TECHNICAL BULLETIN

[Issue No.] FA-A-0131

[Title] Change in a temperature control module, the Q64TCTTBW

[Date of Issue] February 2012

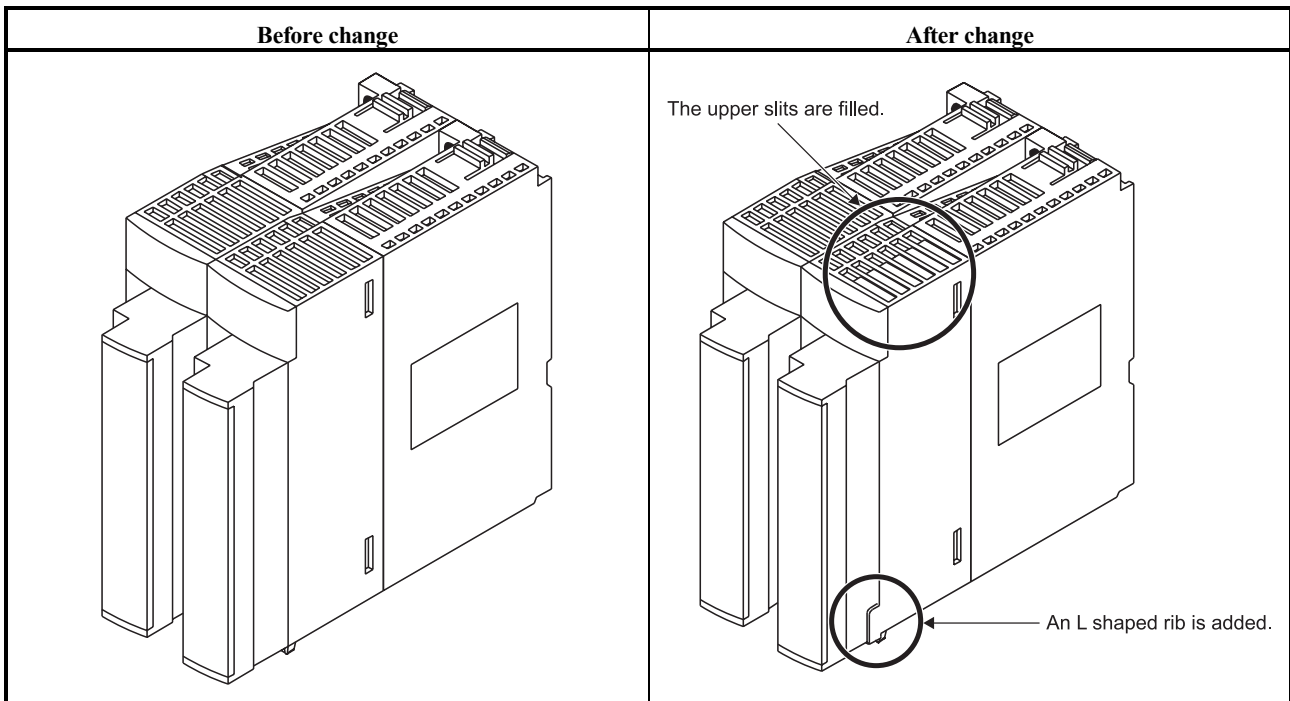
To improve environment resistance, a MELSEC-Q series temperature control module, the Q64TCTTBW will be partly changed.

The change will be made to the encircled parts in the figure below.
